**WHITESTONE**  
solar farm

# Targeted Consultation Leaflet

4 March – 3 April 2026

## **We are now carrying out an additional, targeted consultation on proposed changes to the boundary of Whitestone Solar Farm, known as the ‘draft order limits’.**

## Change 13a: Cable Route East of Treeton

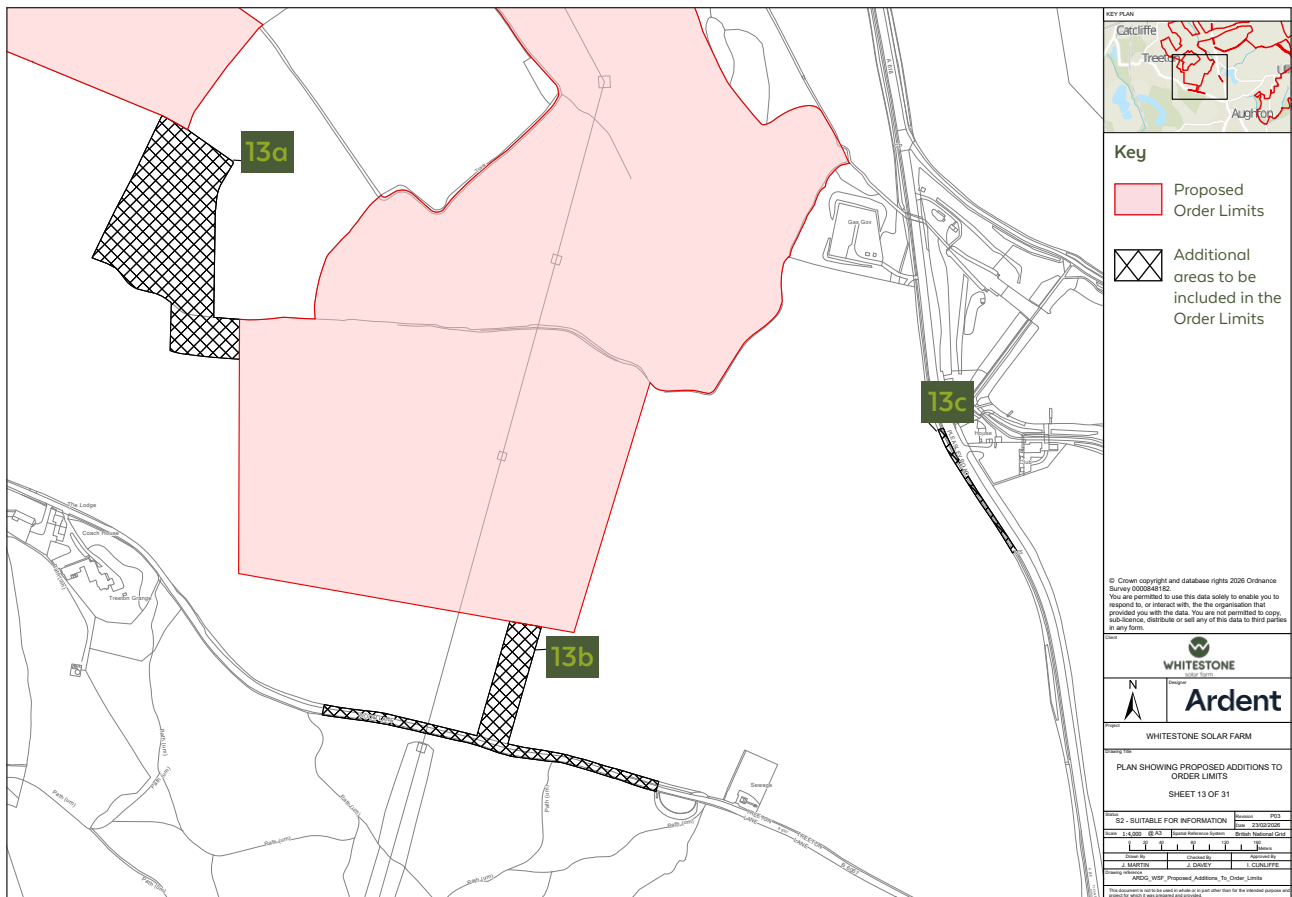
**Description of Change:** Additional land is proposed west of Burnt Wood and east of Treeton to provide for an alternative cable route option to Cable Route G-1. This alternative cable route is likely to be a better engineering route to connect the solar areas north of Treeton due to the topography of the land.

**Impact of Change:** This change is not anticipated to result in any impacts that are not already being considered within the EIA being undertaken to support the Proposed Development. Construction work will be managed in a way to minimise any disturbance on receptors through an Outline Construction Environmental Management Plan. This change is unlikely to lead to significant adverse effects.

## Changes 13a, 13b and 13c continued

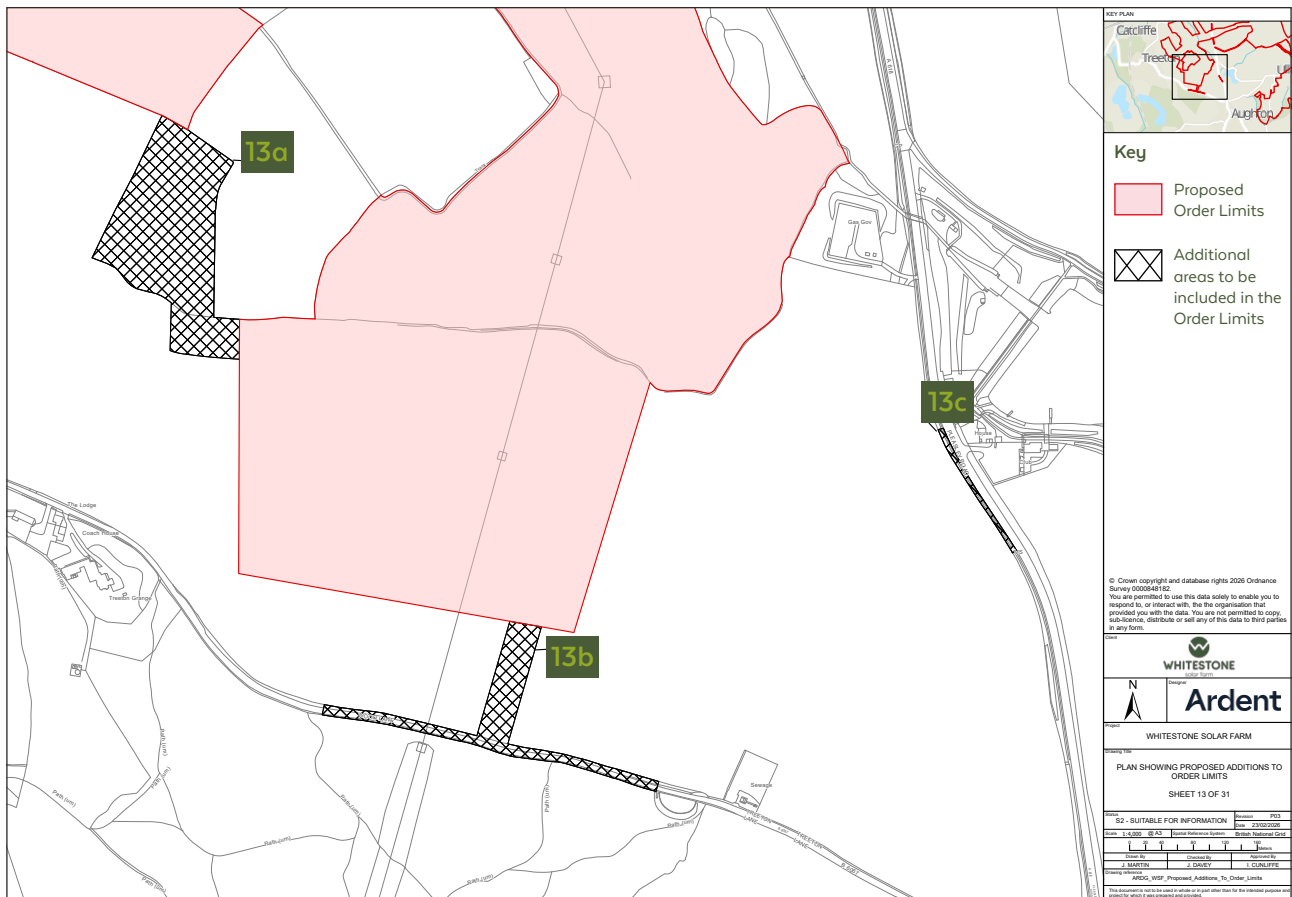
**Description of Change:** Additional land is proposed along Treeton Lane to provide an additional access point to and from the solar area. This change has been proposed in response to consultation feedback about the potential traffic impacts of the proposed access point on Long Lane. This access point is being proposed in addition to the access point on Long Lane to either reduce traffic impacts on Long Lane, or remove that access point altogether. The proposed access includes additional land to access solar area, to comply with highway safety standards for visibility and temporary speed limits if required. The works could include trimming hedges or roadside vegetation for safe visibility, temporary road signage for managing safe access and temporary speed limits during construction.

**Impact of Change:** This change may lead to the loss of hedgerow and roadside vegetation. This impact is already being considered within the EIA being undertaken to support the Proposed Development. The Proposed Development will include significant commitments to planting new hedgerows and creation of additional areas of habitat including safeguarding of any species as needed. With suitable mitigation, this change is unlikely to lead to significant adverse effects.

**Description of Change:** Additional land along Pleasley Road (A618) is being proposed for landscaping to minimise potential glint and glare impacts on the adjacent road. Works could include the planting of trees, hedges or other landscaping and visual barriers as needed.

**Impact of Change:** The impact is dependent on type of visual screening. There is a preference for planting of hedgerows and trees which would have beneficial impacts on habitat creation and connectivity. It may be necessary to install temporary fencing whilst vegetation establishes, however it is expected that any adverse impact would be not significant as receptors would be driving and views impacted would be fleeting.

## Changes 14a, 14b and 14c continued

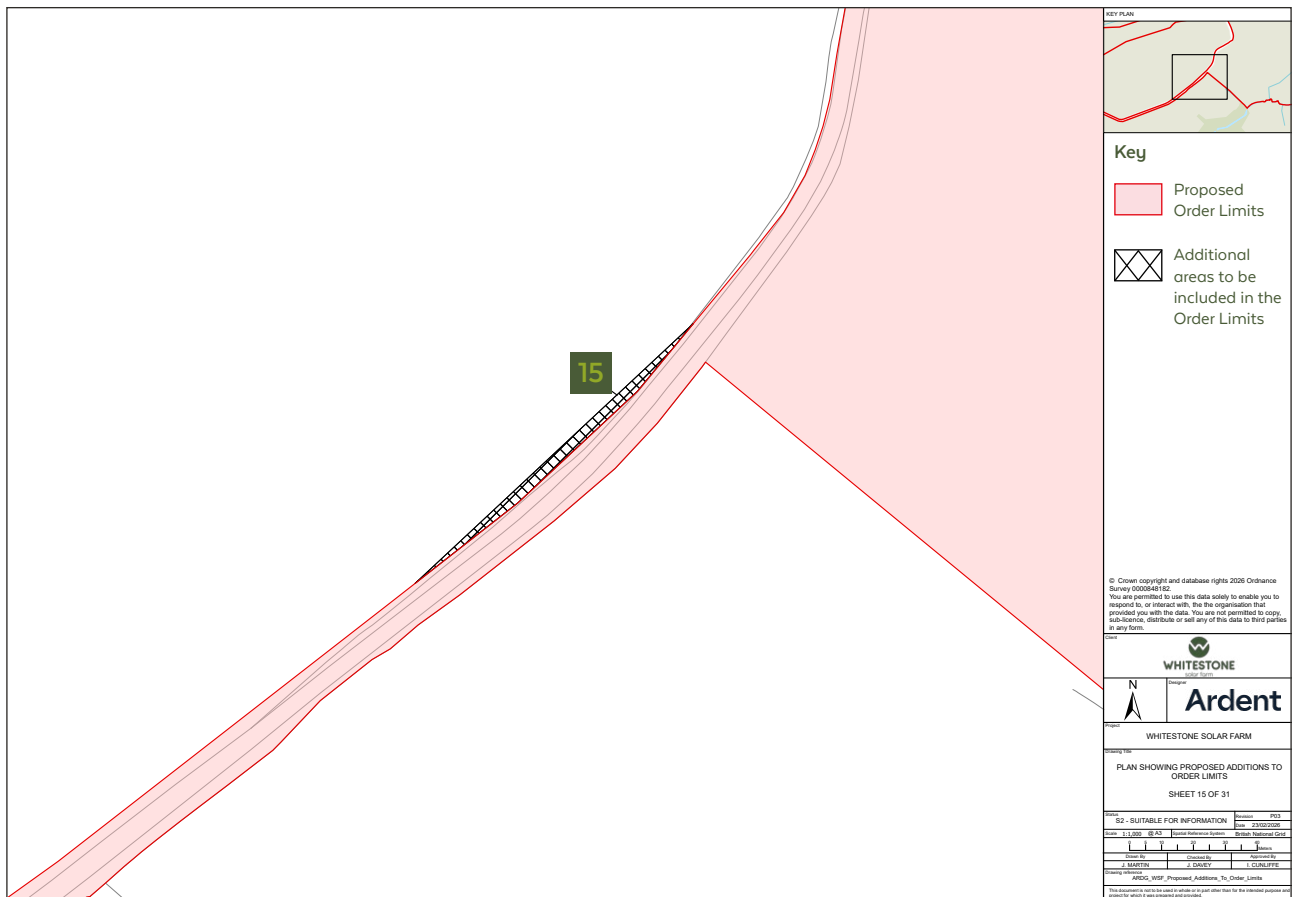
**Description of Change:** Additional land is proposed to allow the proposed access to solar area to comply with highway safety standards for visibility and temporary speed limits if required. The works could include trimming hedges or roadside vegetation for safe visibility, temporary road signage for managing safe access and temporary speed limits during construction if required.

**Impact of Change:** This change may lead to the loss of hedgerow and roadside vegetation. This impact is already being considered within the EIA being undertaken to support the Proposed Development. The Proposed Development will include commitments to planting new hedgerows and creation of additional areas of habitat including safeguarding of any species as needed. With suitable mitigation, this change is unlikely to lead to significant adverse effects.

**Description of Change:** This area of the Cable Route F has been reduced to the southern boundary to avoid hedgerow and so increased slightly to the northern boundary to have sufficient flexibility for safe construction of the cable corridor.

**Impact of Change:** This change is not anticipated to result in any impacts that are not already being considered within the EIA being undertaken to support the Proposed Development. Construction work will be managed in a way to minimise any disturbance on receptors through an Outline Construction Environmental Management Plan. This change is unlikely to lead to significant adverse effects.

# Change 16: Road Safety on Brampton Lane

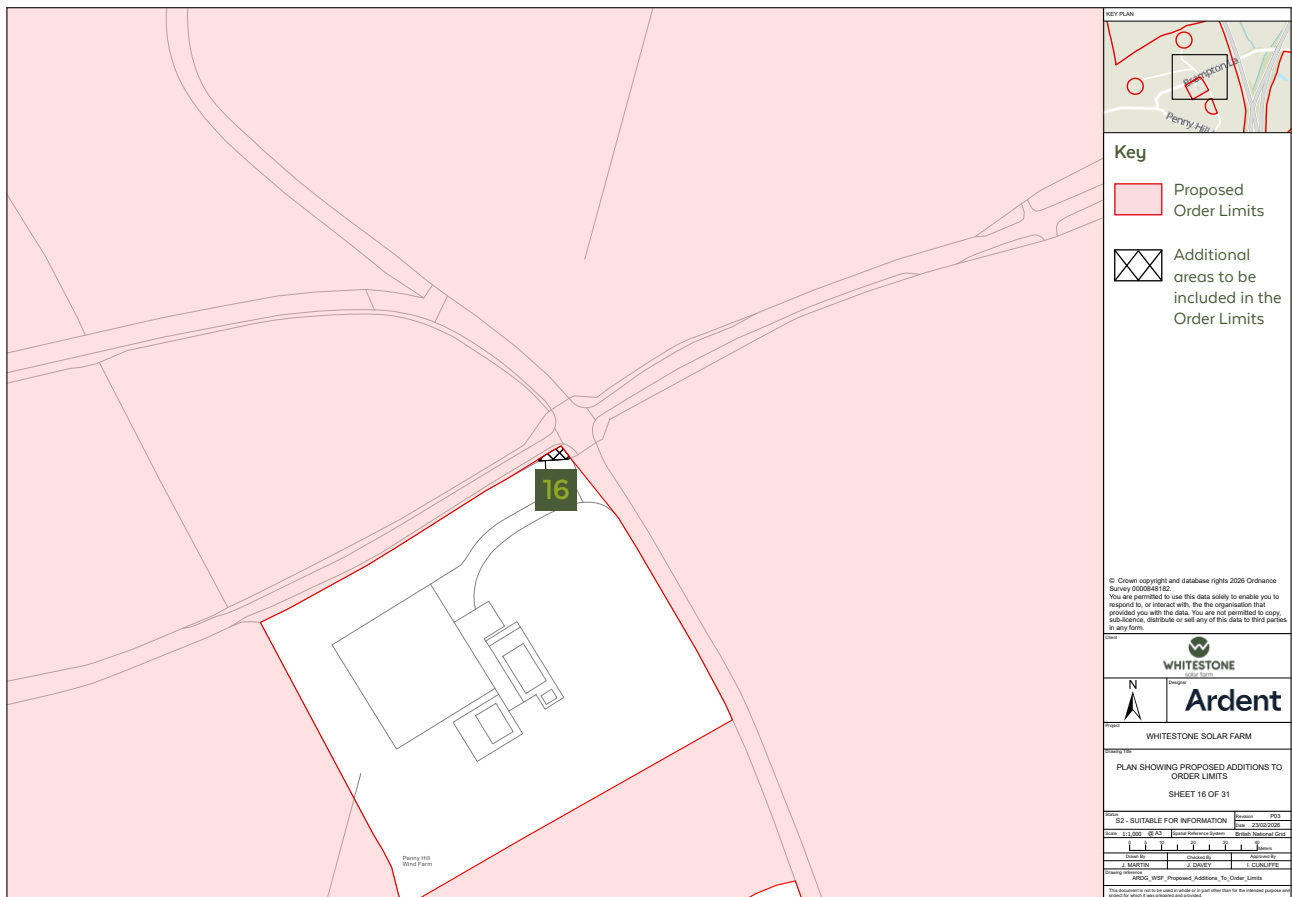
**Description of Change:** Additional land is proposed on Brampton Lane near Penny Hill Wind Farm to allow the proposed access to solar area to comply with highway safety standards for visibility and temporary speed limits if required. The works could include trimming hedges or roadside vegetation for safe visibility, temporary road signage for managing safe access and temporary speed limits during construction if required.

**Impact of Change:** This change may lead to the loss of hedgerow and roadside vegetation. This impact is already being considered within the EIA being undertaken to support the Proposed Development. The Proposed Development will include commitments to planting new hedgerows and creation of additional areas of habitat including safeguarding of any species as needed. With suitable mitigation, this change is unlikely to lead to significant adverse effects.

# Change 17: Road Safety South of Brampton en le Morthen

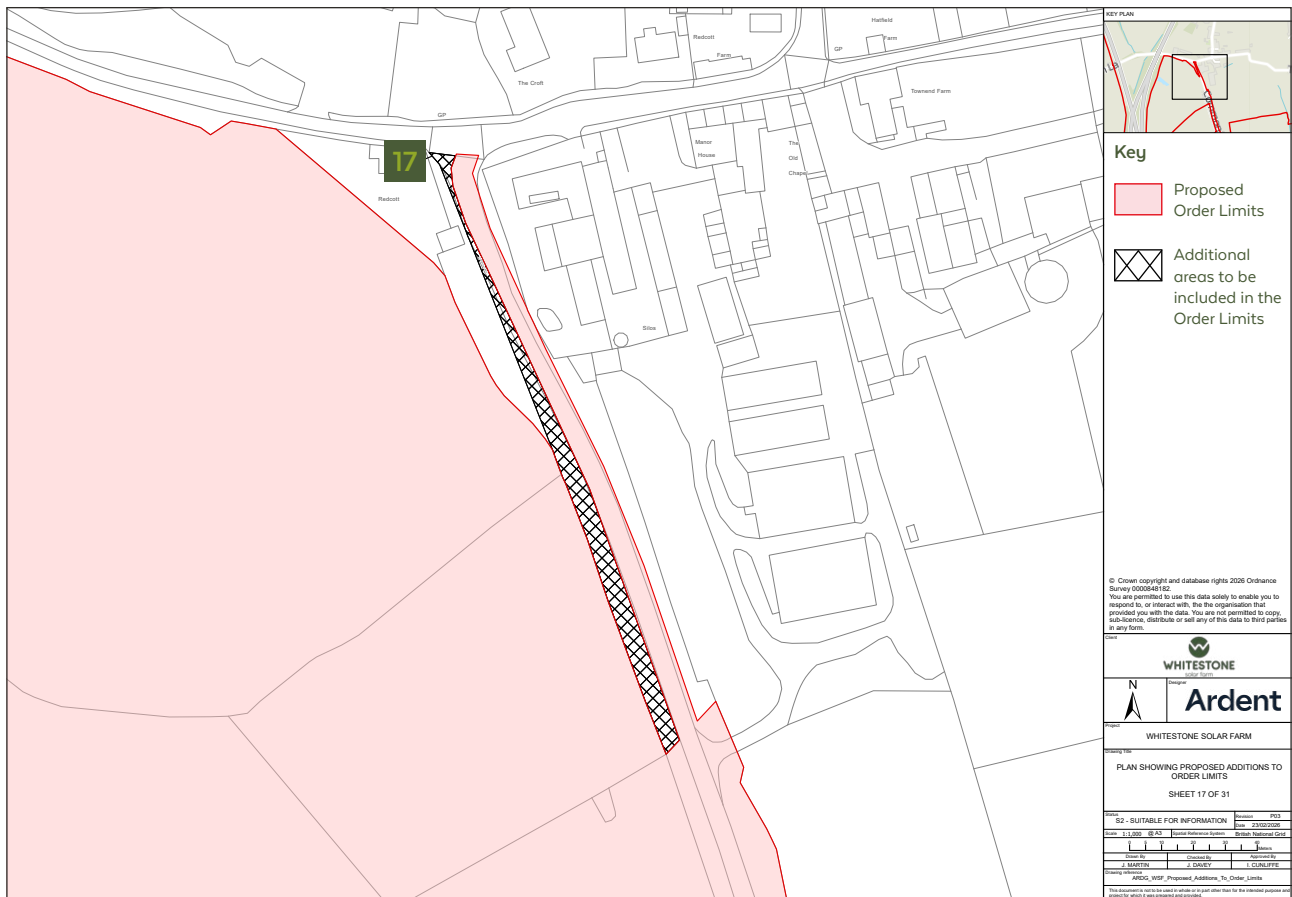
**Description of Change:** Additional rights may be needed along Common Lane south of Brampton en le Morthen to allow the proposed access to solar area to comply with highway safety standards for visibility and temporary speed reductions if required. The works could include trimming hedges or roadside vegetation for safe visibility, temporary road signage for managing safe access and temporary speed limits during construction if required.

**Impact of Change:** This change may lead to the loss of hedgerow and roadside vegetation. This impact is already being considered within the EIA being undertaken to support the Proposed Development. The Proposed Development will include commitments to planting new hedgerows and creation of additional areas of habitat including safeguarding of any species as needed. With suitable mitigation, this change is unlikely to lead to significant adverse effects.

# Change 18: Road Safety South of Thurcroft

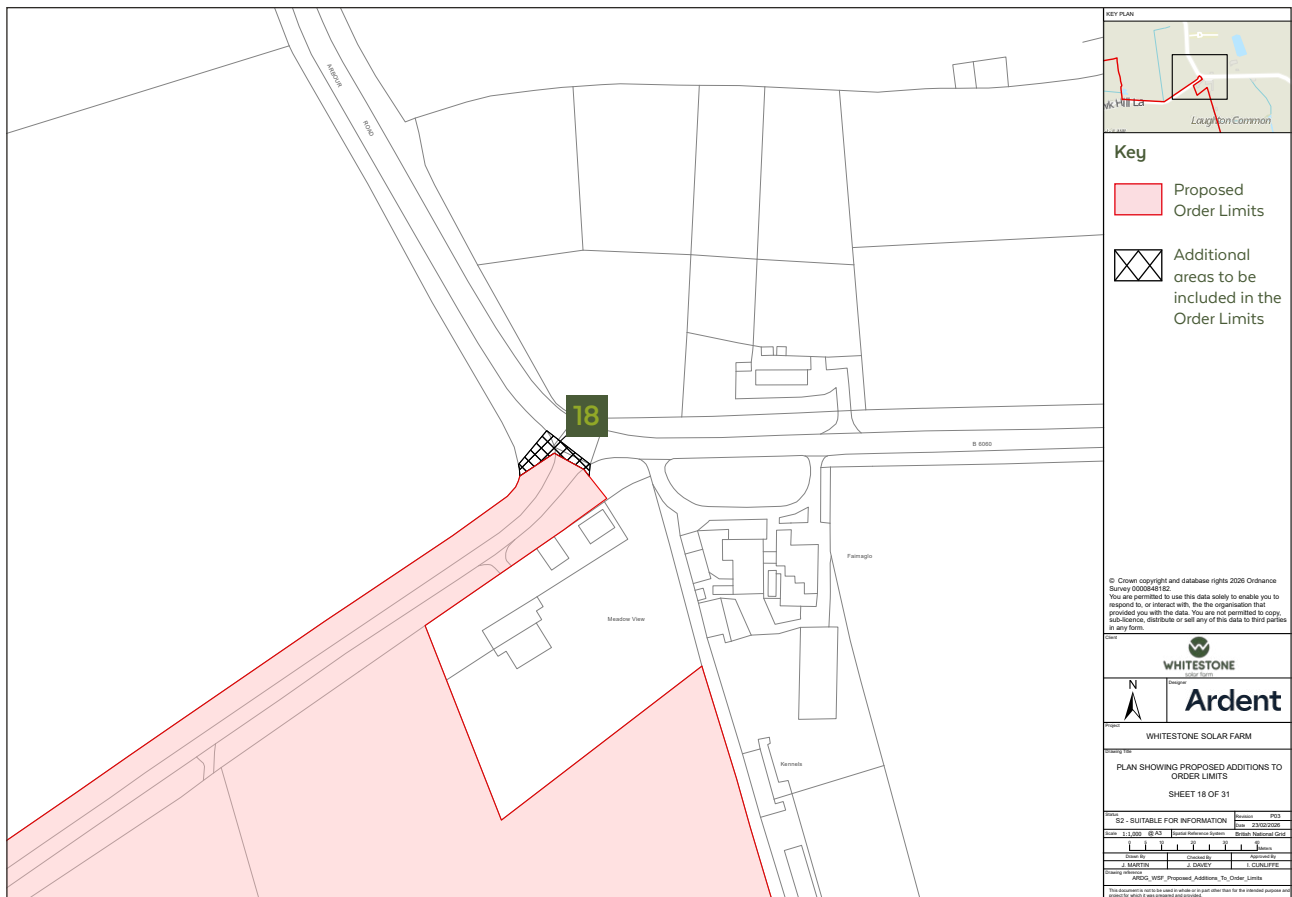
**Description of Change:** Additional land is proposed at the junction of Hawk Hill Lane and Green Arbour Road south of Thurcroft to allow the proposed access to the solar area to comply with highway safety standards for visibility and temporary speed limits if required. The works could include trimming hedges or roadside vegetation for safe visibility, temporary road signage for managing safe access and temporary speed limits during construction if required.

**Impact of Change:** This change may lead to the loss of hedgerow and roadside vegetation. This impact is already being considered within the EIA being undertaken to support the Proposed Development. The Proposed Development will include commitments to planting new hedgerows and creation of additional areas of habitat including safeguarding of any species as needed. With suitable mitigation, this change is unlikely to lead to significant adverse effects.

## Change 20: Road Safety South of North Anston

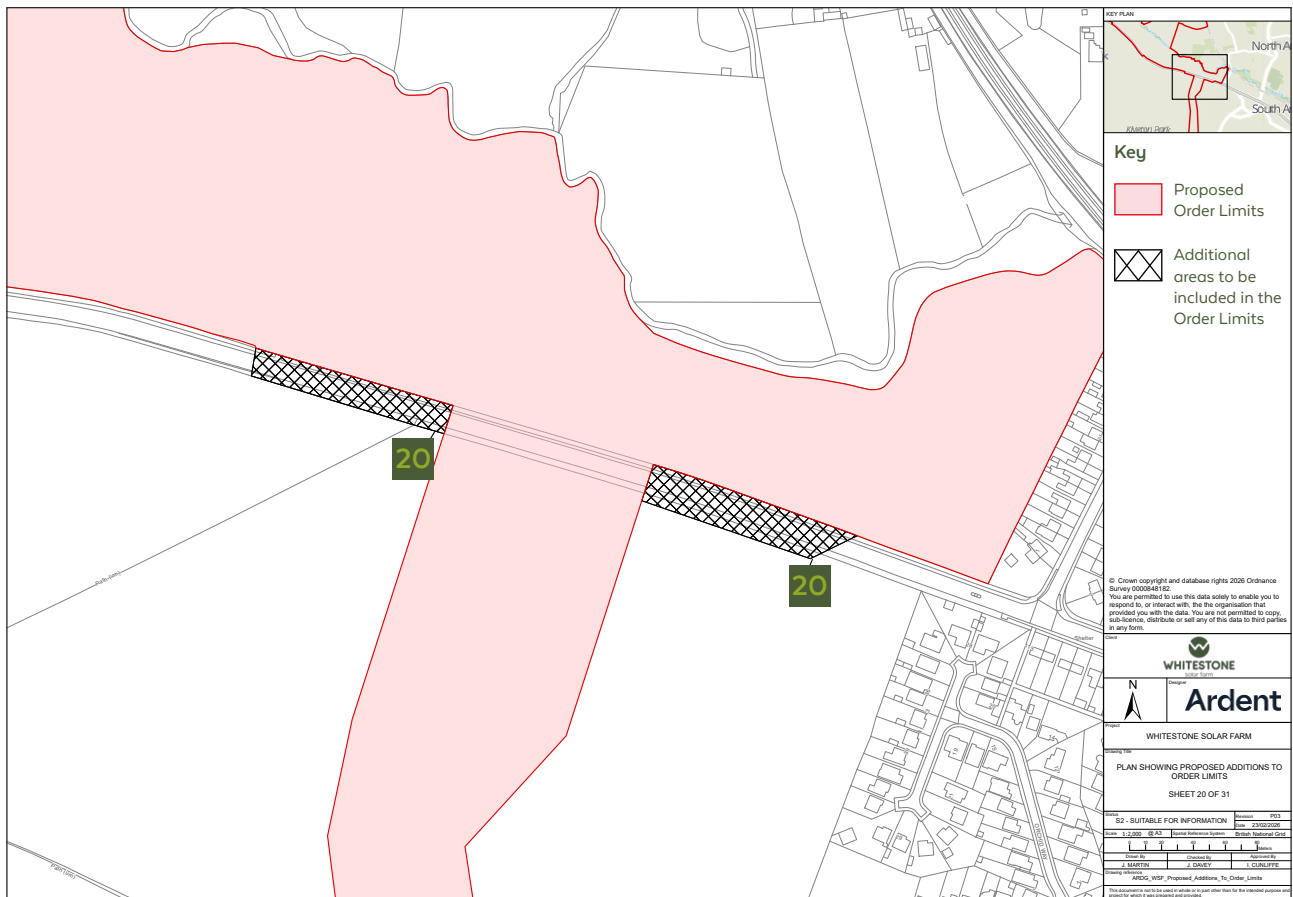
**Description of Change:** Additional land is proposed along the A57 south of North Anston to allow the proposed access to Cable Route L, to comply with highway safety standards for visibility and temporary speed limits if required. The works could include trimming hedges or roadside vegetation for safe visibility, temporary road signage for managing safe access and temporary speed limits during construction if required.

**Impact of Change:** This change may lead to the loss of hedgerow and roadside vegetation. This impact is already being considered within the EIA being undertaken to support the Proposed Development. The Proposed Development will include commitments to planting new hedgerows and creation of additional areas of habitat including safeguarding of any species as needed. With suitable mitigation, this change is unlikely to lead to significant adverse effects.
